### **Millcreek Dump Superfund Site**

REMEDIATION SYSTEM EVALUATION

Report of the Remediation System Evaluation  
Site Visit Conducted at the Millcreek Dump Superfund Site  
September 2, 2009

Revised Report  
February 16, 2010

Figure 1. Alternate groundwater flow paths.

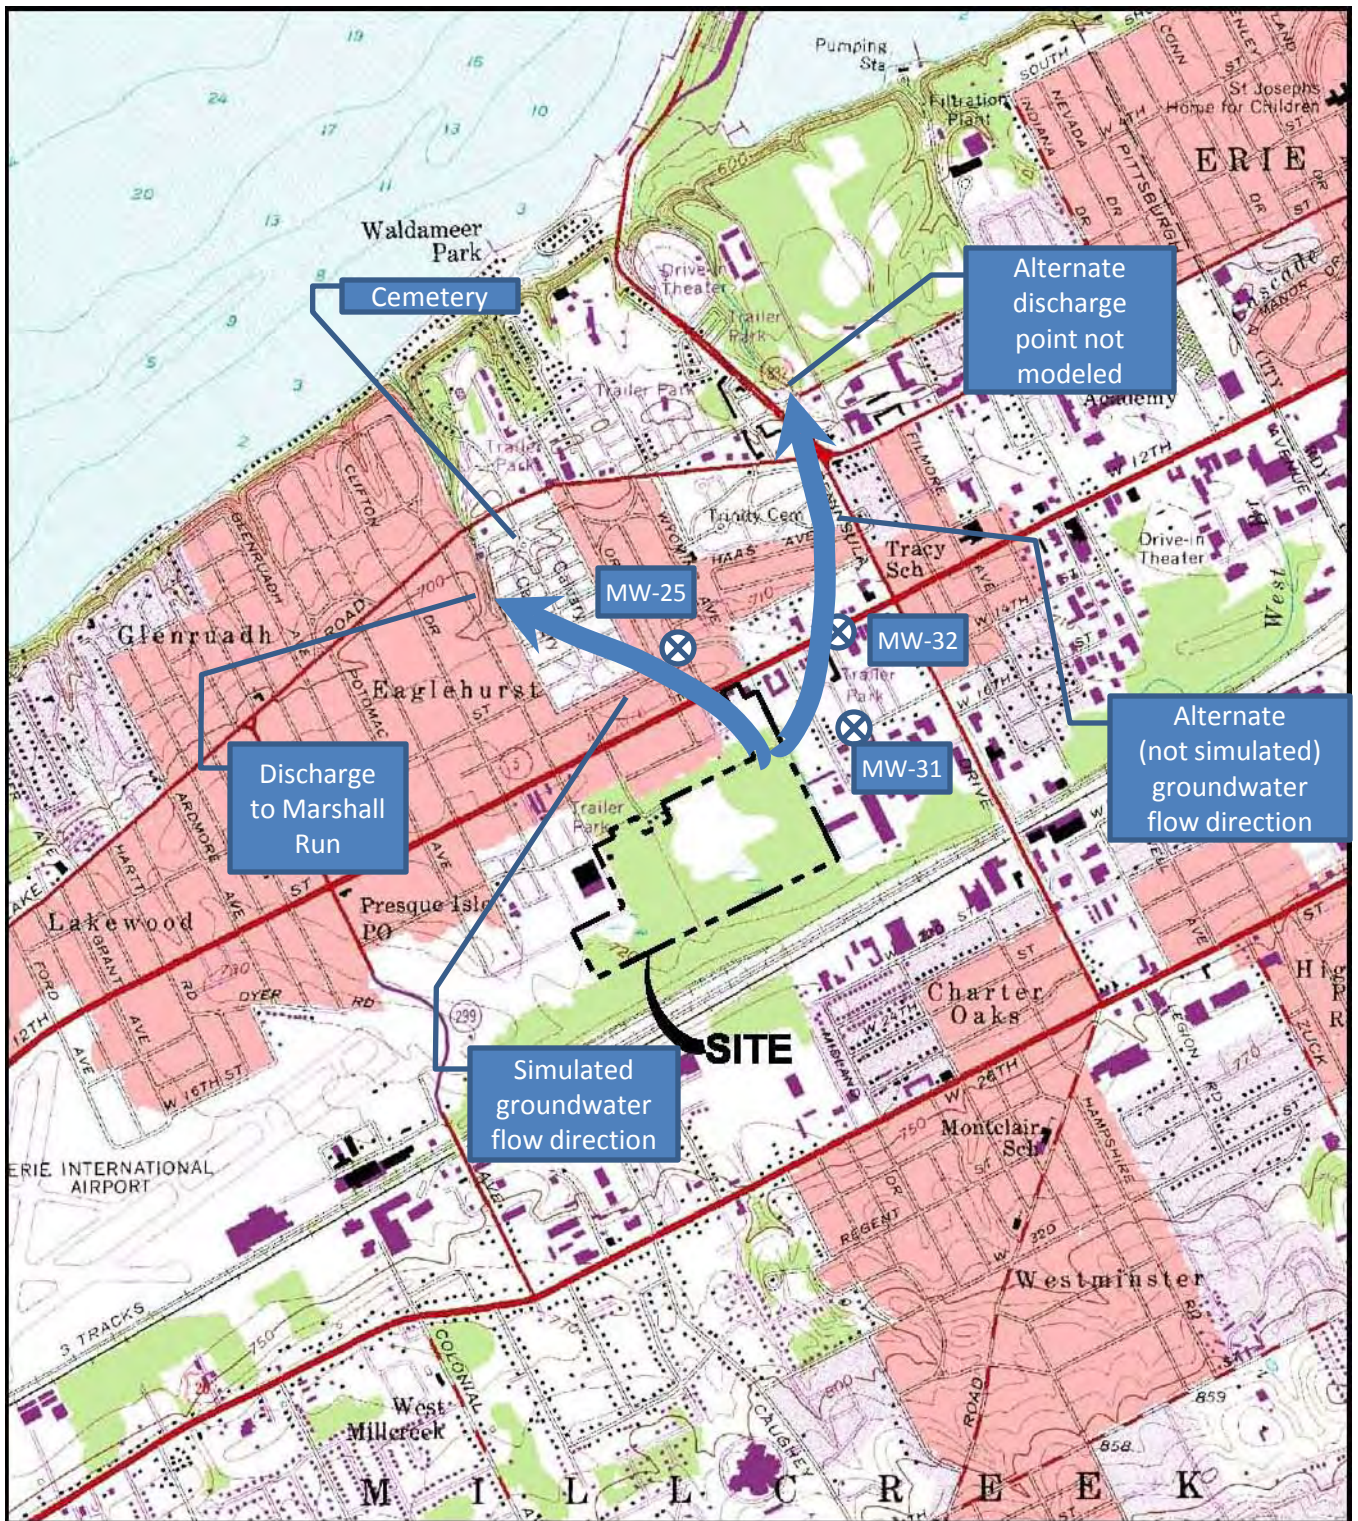
- Insufficient water level information is available to determine the direction of ground water flow north of the site to clearly establish regional ground water flow and the fate of contamination after it leaves the landfill. The figures indicate that water flows toward Marshall Run to the west of the cemetery; however, there is another equally likely location for ground water to discharge to surface water near the intersection of 8<sup>th</sup> Street and Peninsula Drive (see Figure 1). Contamination has been detected at MW-32 (in the direction of 8<sup>th</sup> Street and Peninsula Drive) to an equal or greater extent than at the MW-25 cluster (in the direction of the cemetery).

Figure 2. Suggested direct-push locations

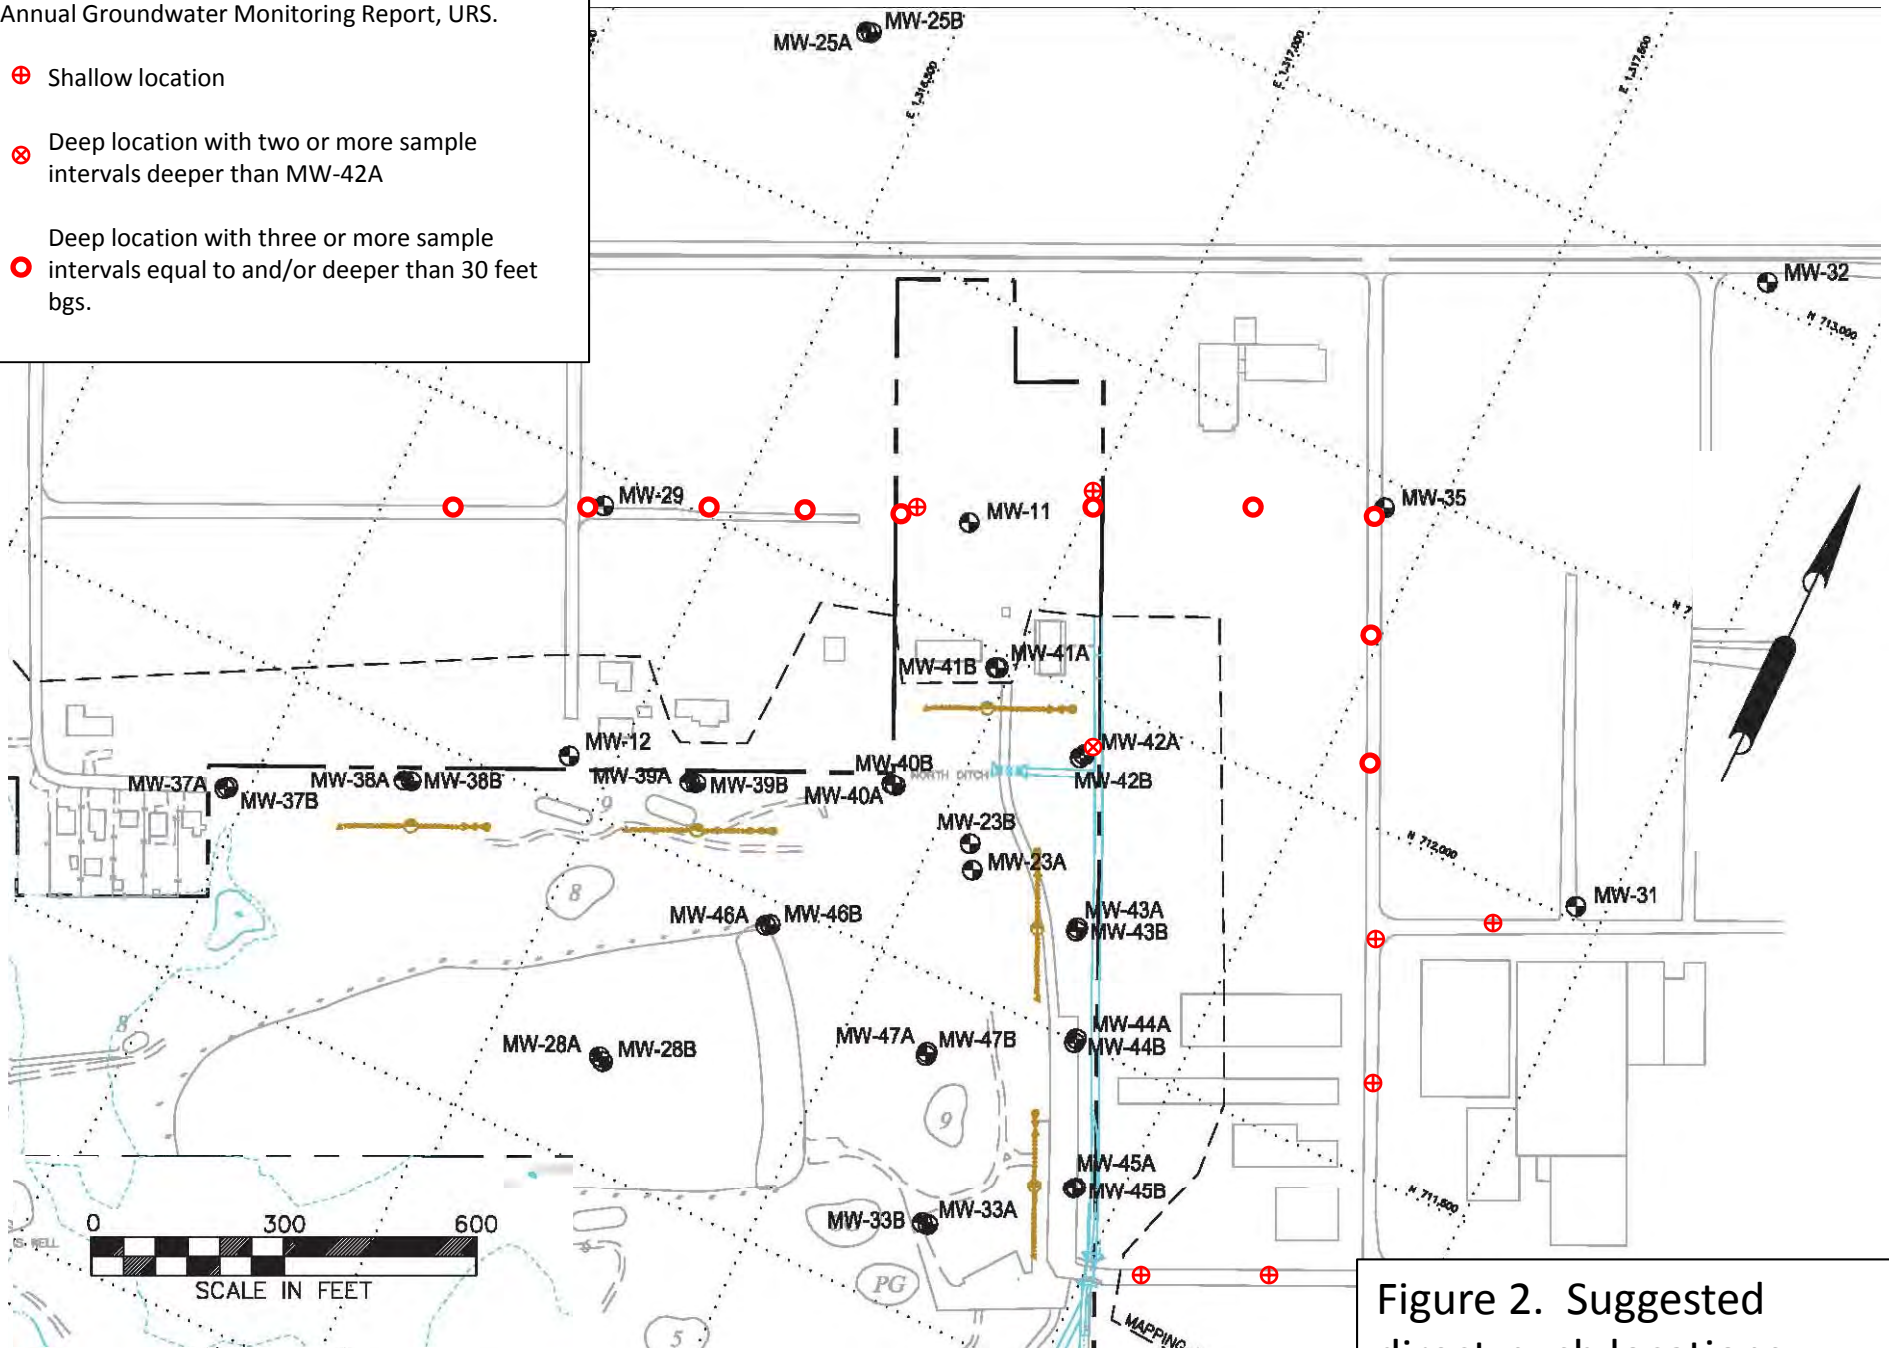
The plume is not vertically delineated (particularly near MW-42A), and there is an insufficient number of wells off-property to horizontally delineate the contamination or monitor concentration trends in the shallow zone (Zone B), intermediate zone (Zone A), and deep zone (deeper than Zone A). The RSE team suggests the following additional characterization by using direct-push drilling to collect grab samples. Suggested sample locations are presented in Figure 2:

- Horizontally delineate the contamination at MW-42A (and any contamination detected deeper than MW-42A) to the northwest, north, and northeast. Collect grab samples at three more depth intervals equal to or deeper than MW-42A to the northwest, north, and northeast of MW-42A (see Figure 2 for potential locations). The results of these samples will help identify pathways where contamination has not been captured by the extraction system over the past 10 years. Where contamination is identified at concentrations comparable to on-property concentrations, permanent monitoring wells may be appropriate for long-term monitoring of concentration trends (see Section 6.1.2).

- Determine if contamination is present downgradient of MW-39A, MW-40A, and MW-41A off-property at depth. Collect grab samples off-property to the northwest of these wells in multiple locations at three or more depth intervals that are equal in depth or deeper than these wells. See Figure 2 for suggested locations. The results of these samples will help identify pathways where contamination has not been captured by the extraction system over the past 10 years. Where contamination is identified at concentrations comparable to on-property concentrations, permanent monitoring wells may be appropriate for long-term monitoring of concentration trends (see Section 6.1.2). Note that the RSE team has not specifically recommended vertical delineation in the vicinity of MW-39A, MW-40A, and MW-41A. The RSE team believes that these locations are likely within the capture zones of the trenches and the detection of contamination in these locations would not necessarily contribute to plume delineation and capture zone evaluation in the same manner as the recommended locations. The RSE team,

- Determine if declining concentrations in MW-11 are due to infiltration of clean water from the pond or due to plume capture by the extraction system. Collect grab samples “side-gradient” to MW-11 in Zone B. See Figure 2 for locations.
- Determine if contamination at MW-31 is site-related or due to another source. Collect shallow grab samples between the landfill property and MW-31 as depicted in Figure 2. If contamination at MW-31 is determined to be linked to the Site, then another field event should be conducted to delineate the characterize the contamination at depth.

Figure 2 illustrates a total of 15 locations and a total of 39 samples. The RSE team has attempted to locate the sample points where access will not be an issue. The RSE team estimates that this characterization may take up to 8 days in the field at an approximate cost of \$50,000, including laboratory analysis, waste disposal, preparation of boring logs, and reporting. These costs and this recommendation do not include the installation of permanent monitoring wells that may be needed for long-term monitoring in these locations. The following recommendation involves the installation of some permanent points, but other permanent monitoring wells may be needed as well.
